ONE SYDNEY HARBOUR

BARANGAROO

R4A SUPPLEMENTARY DESIGN STATEMENT FOR S4.55 MODIFICATION
November 2020

North East Elevation, Uppermost levels blow-up - Proposed

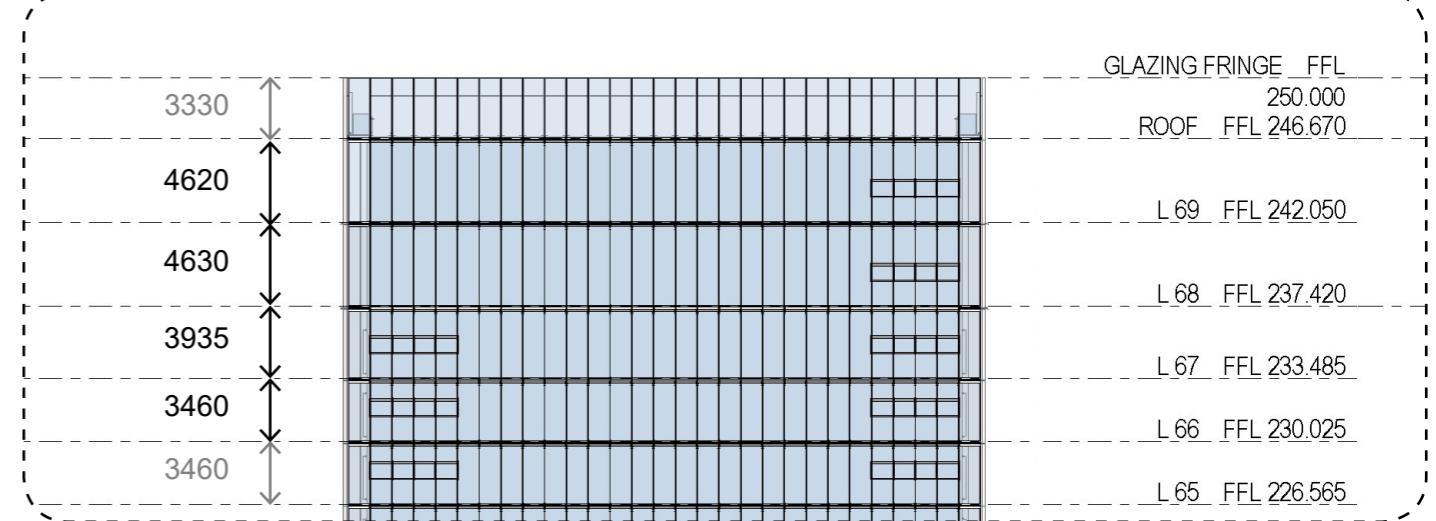
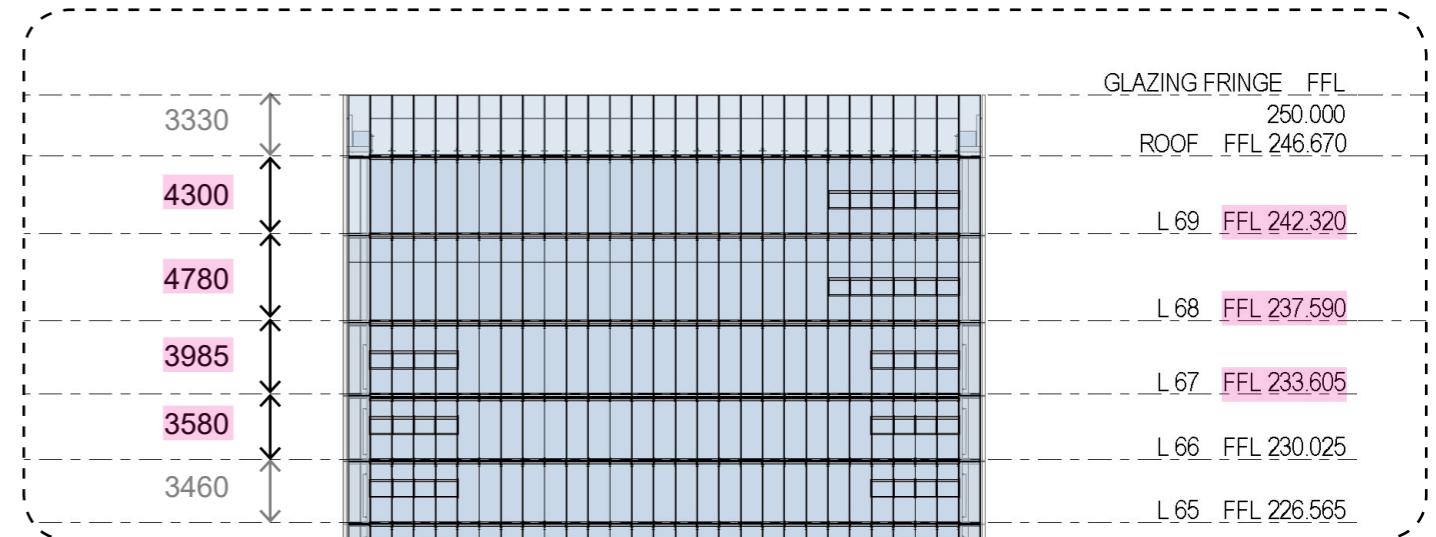
Finished Floor levels of L67, L68 and L69 have been reviewed and refined to accommodate improved ceiling heights and to achieve required floor finishes and ceiling services zones.

Roof and parapet levels shall remain unchanged. Finished Floor Levels up to and including L66 will also remain unchanged from the existing approved levels.

Proposed L67 Plan - Sub Penthouse

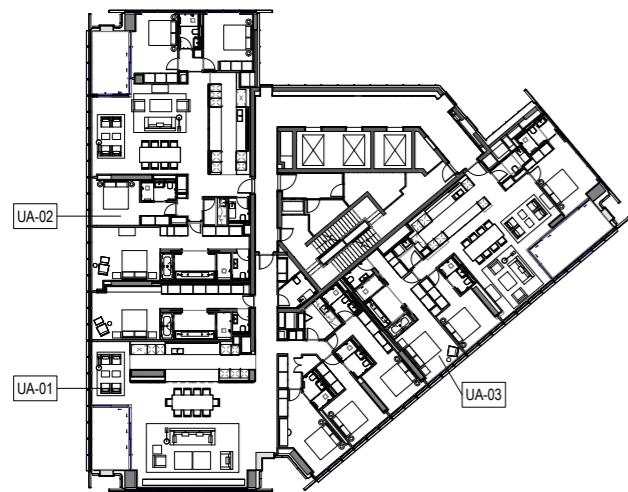
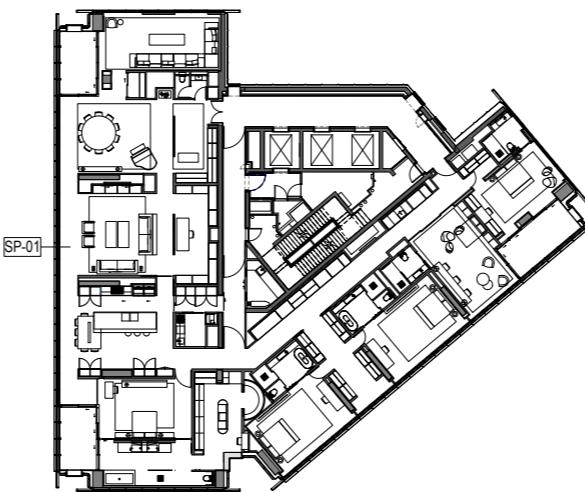
The first amendment is to the uppermost floor plate of the R4A Tower, and involves changing the typical Upper Plate on L67 to a new “Sub PH Plate”.

This new plan layout is configured as a single apartment instead of the three individual ones, consequently reducing the total number of apartments in the tower by two (from 317 to 315). This change has been enacted to better cater the high-quality demands envisaged for such a unique position in the tower.

Proposed L68 Plan - Lower PH

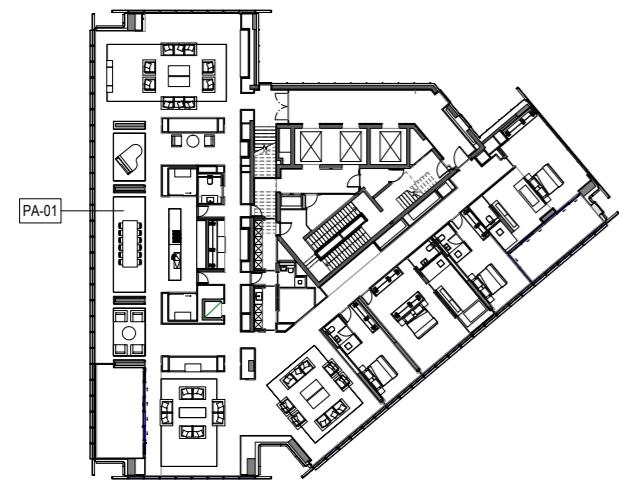
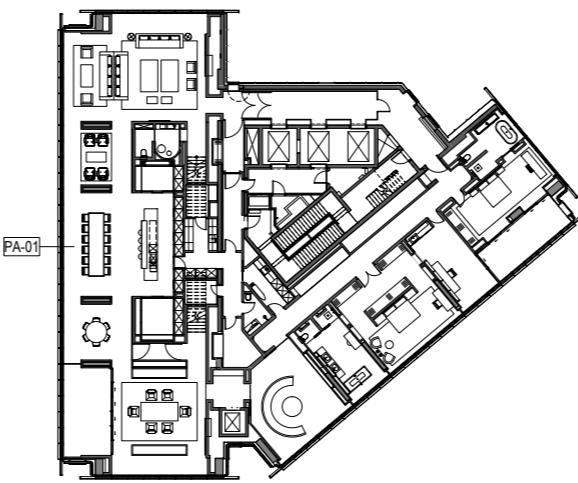
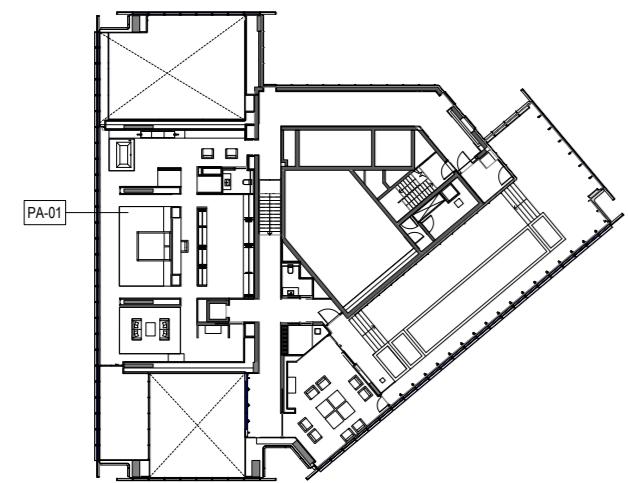
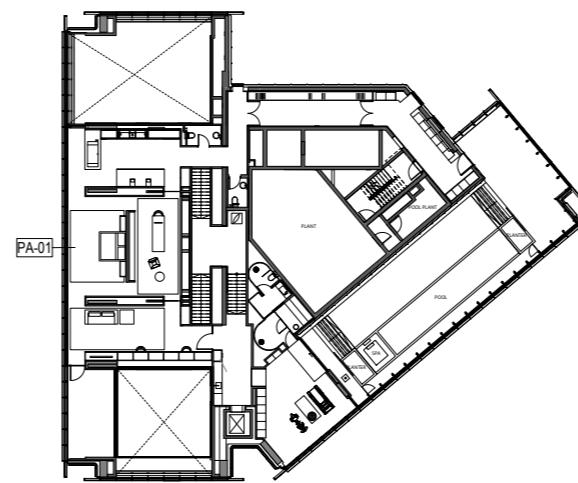
As mentioned in the previous section, L67 has been subjected to a revised floor plate design, but L68 and L69 have also undergone refinements. The following drawings are the result of a meticulous redesign and refinement process undertaken to ensure the highest quality floor plate given the importance of the referred apartments.

These changes result in minimal facade redevelopment, which will be described in the next section

View 1 - Proposed NE Elevation - Tower Top

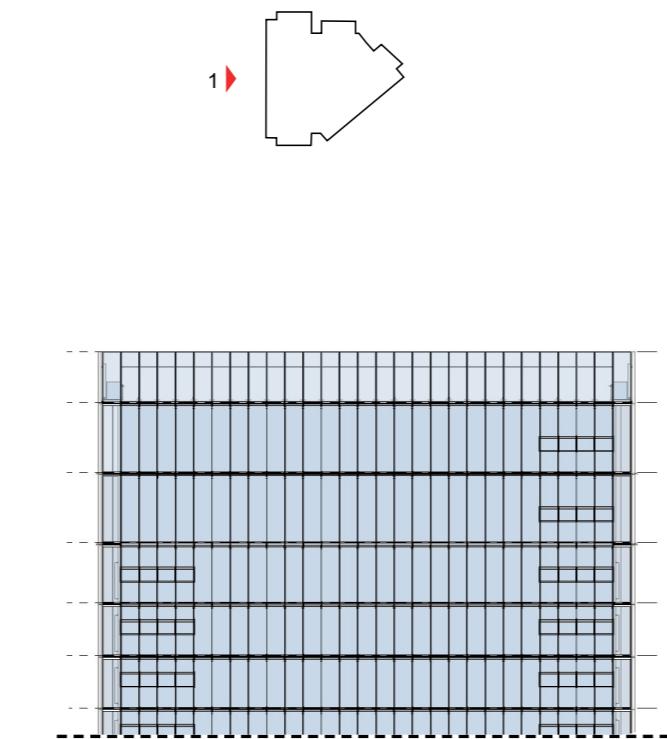
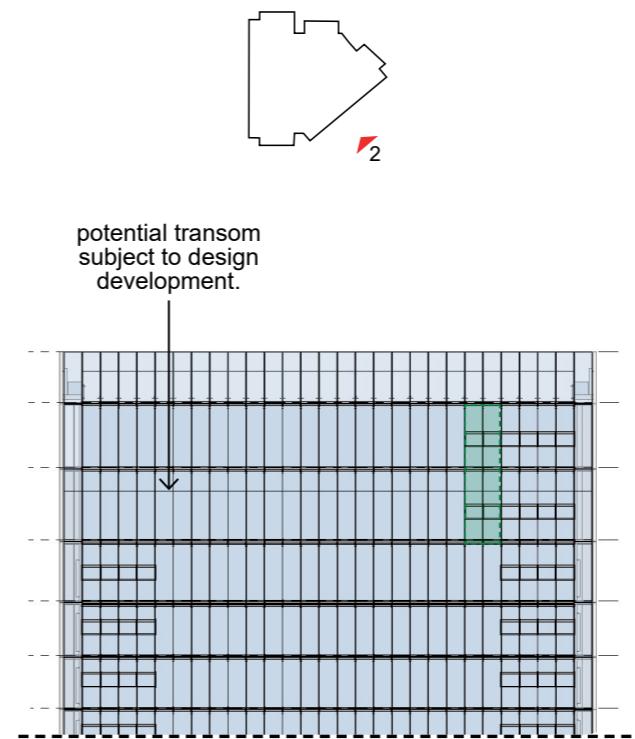
The updates proposed are the extension of the wintergarden with operable sash window by two bays on the NE Façade and by one bay at West Façade. These changes are proposed to meet the outline of the wintergarden in these levels, resulting in a coherent façade following the function it encloses.

Proposed Facade below Pool

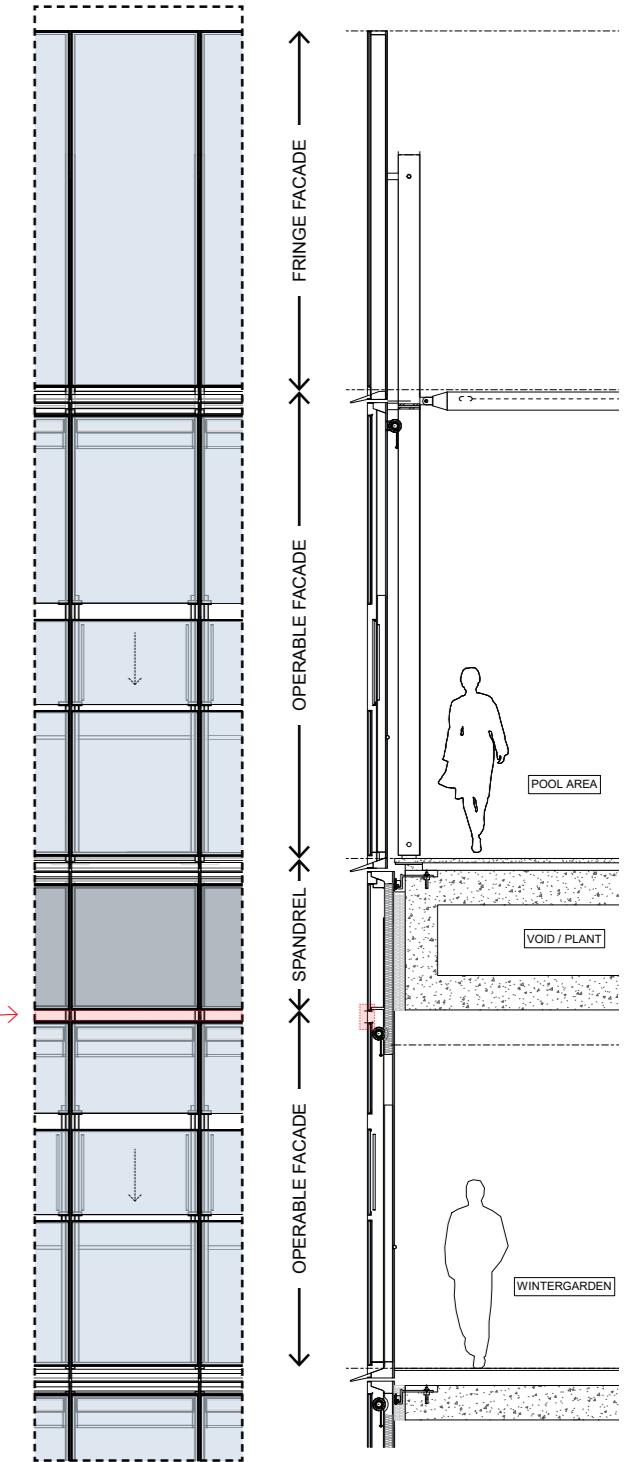
A second change, outlined in red, is the introduction of an additional gap on the west facade. By doing so, the facade is divided in two. An opaque closed cavity portion is enclosed overhead to conceal the pool structure. This portion is visually consistent with glazed spandrel panels as described and approved in the "Exterior Finishes Design Report - Consent B9" from October 2019. The glazed operable facade remains below it, consistent with the ceiling height at that zone. A ventilation gap is proposed to be introduced at this joint, allowing for the functioning of the open cavity facades.

Since the same pool structure impacts also the south facade, it was chosen to extend a minimal intermediary glass transom across the whole tower for consistency, using spandrel where applicable (west, and south facades) and leaving the remaining ones as glazing.

Proposed Roof Plan

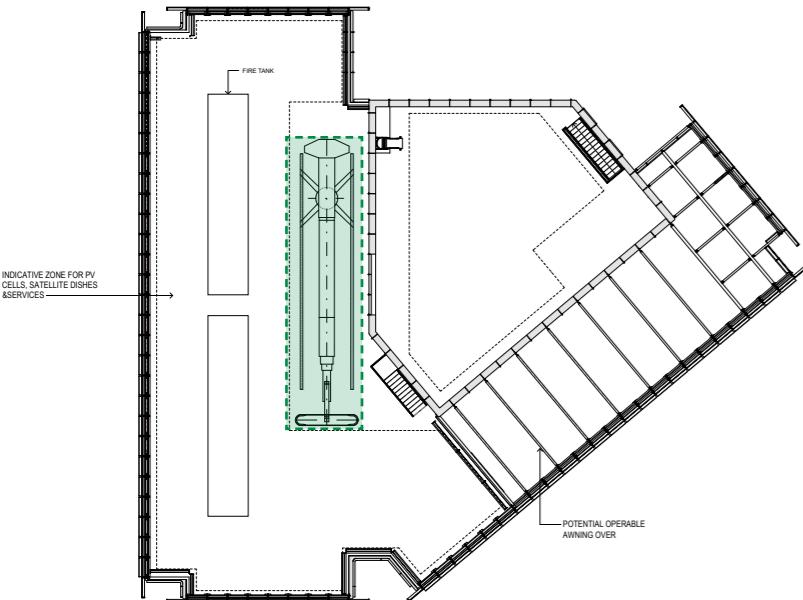
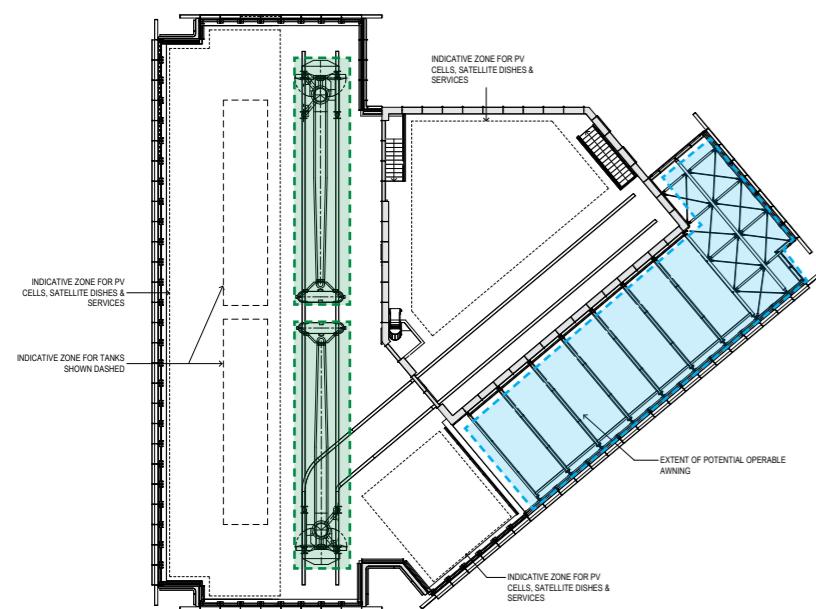
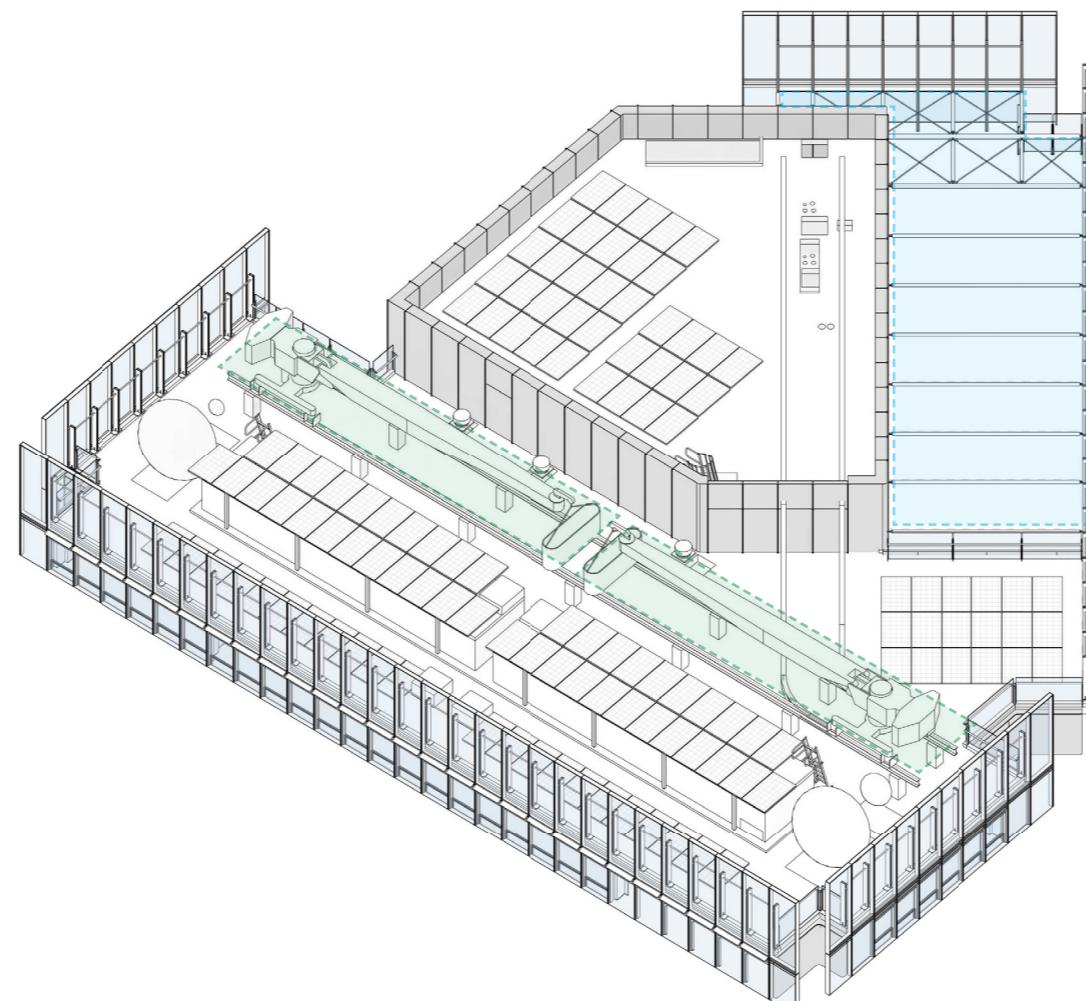
A retractable awning shading system was approved as part of SSD6964. This S4.55 illustrates the proposed extent of retractable shading for clarification and for the avoidance of doubt, being its potential extension over the total roof area.

A second amendment is in regards to a change in the roof Building Maintenance Unit (BMU). Whereas in the approved scheme the tower is serviced by a single BMU, in the proposed scheme, two smaller BMUs are proposed. This solution allows for quicker cleaning cycles and uninterrupted service in case BMU maintenance.

The use of a sloped rail allows the BMU to raise to the top of the LMR and access the southern facade while still parking behind the tanks and remaining below the fringes. Refer to the schematical scheme image to the left.

Building Signage Location zones

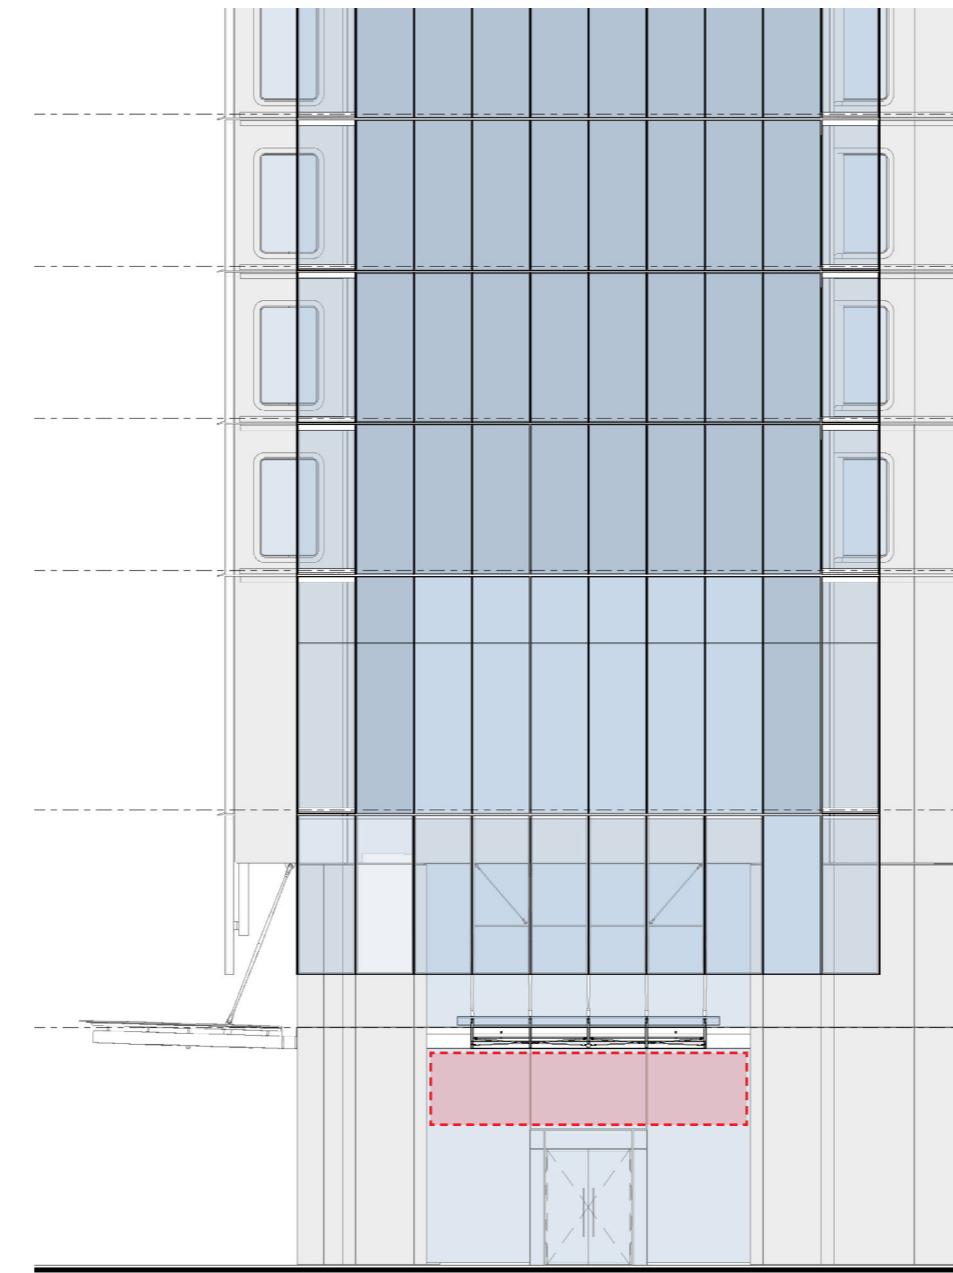
At the ground floor, an amendment is being proposed to provide an additional location for a signage zone for the Building address signage. Whereas before, the placeholder area was set above the entry vestibule, a comprehensive consideration of the surrounding precinct has resulted in re-consideration of the location of building signage.

As a result to this reasoning it was envisaged to use individual lettering on the GRC cladding in the zone dashed in red.

This low-key solution also allows to emphasise the signage of the retail adjoining to the lobby, where a more eye catching signage could be used without competing or being confused with the building address.
